AGENDA

October 18, 2011

STAFF MEMO

Agenda Item #3: Soiland, Inc/H2O Waste Disposal Services, LLC – Hayden Ln – Map 8, Lot 38

SITE PLAN
LOT 8-38
PREPARED FOR
H2O WASTE DISPOSAL
SERVICES, LLC
MILFORD, NEW HAMPSHIRE
SCALE: 1" = 20' **DECEMBER 3, 2010**

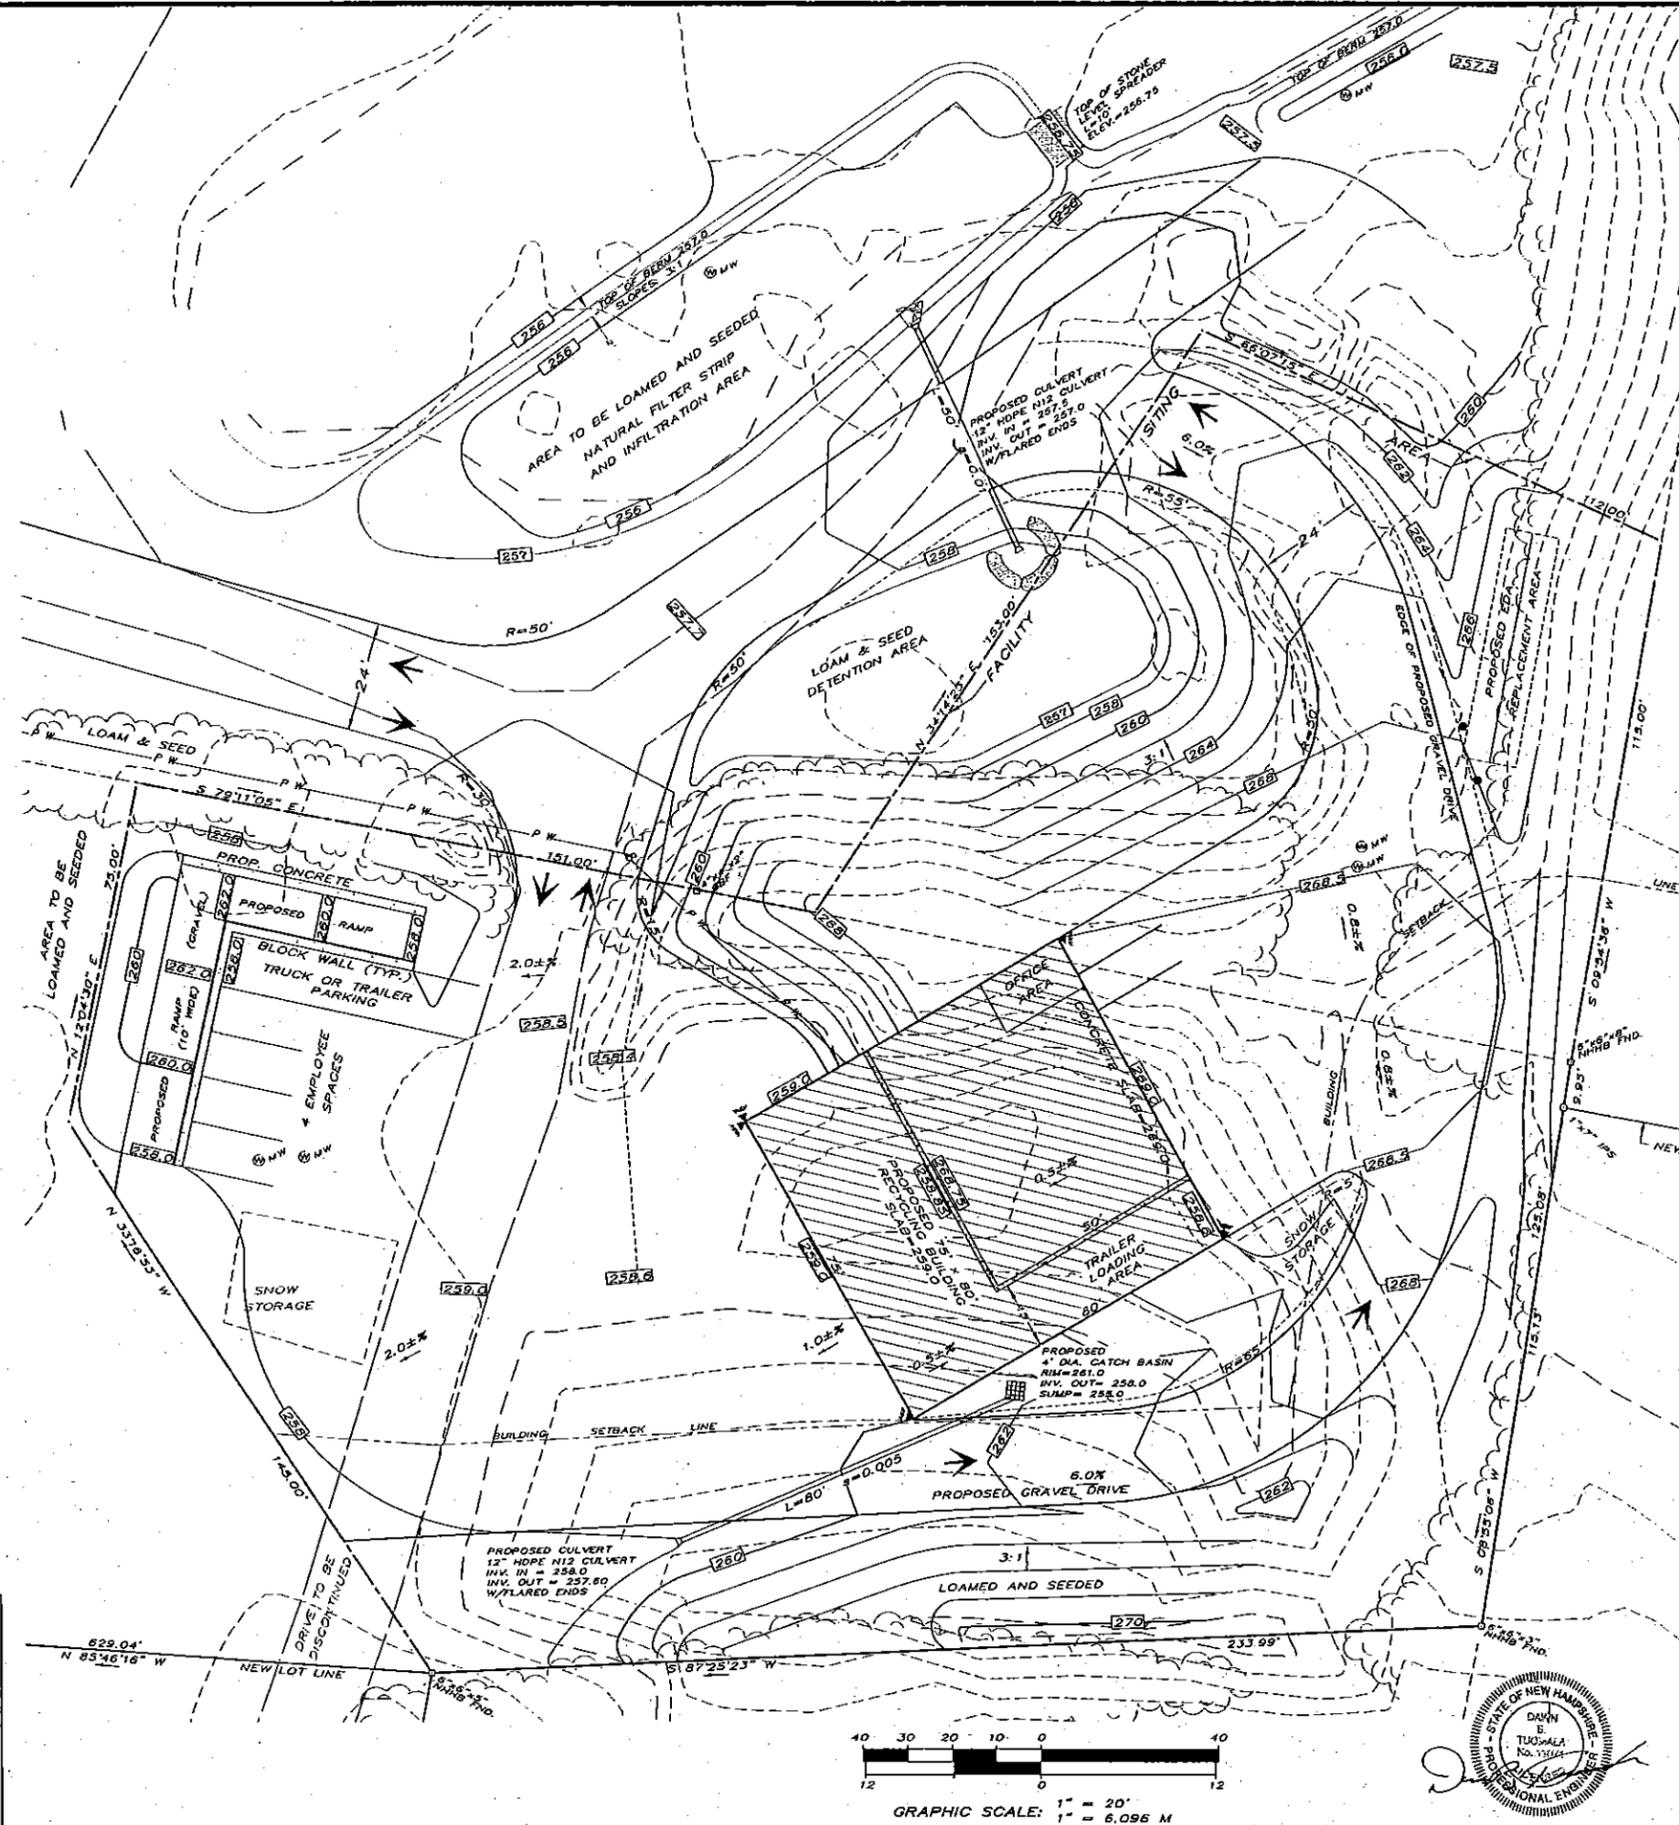
1. Stormwater compliance review pending. Yet to receive SW application and associated documents.
2. The facility appears to have grown in size from the original proposal w/ separate trailer storage and loading area. Will this require containment? Is the proposed surface impervious?

On Sheet 1, Note #11 currently says all storage of materials will be within the proposed building, however in the DES response letter it says materials will be stored in a trailer outside of the building. Please clarify if materials are or are not proposed to be stored outside of the building or if other storage options are under consideration. Any approved outside storage areas must be clearly detailed on the site plan.

- 1) Note #20, Sheet 1 be amended to include the revised NHDES Permit by Notification for Collection Center for Select Recyclables approval date and permit number.
- 2) A Note be added to include the NHDES Subsurface System Approval number.
- 3) Access easement be finalized and provided for recording with the final plan set.
- 4) Locate and detail any gates for the facility in accordance with DES requirements
- 5) Locate and detail 'hot load' area on site plan in accordance with DES requirements
- 6) Note #11, Sheet 1 be updated based on PB discussion
- 7) Remove Note #27, Sheet 1
- 8) The area to be planted with Christmas Trees as agreed upon in December 2010 shall be detailed on the plan.
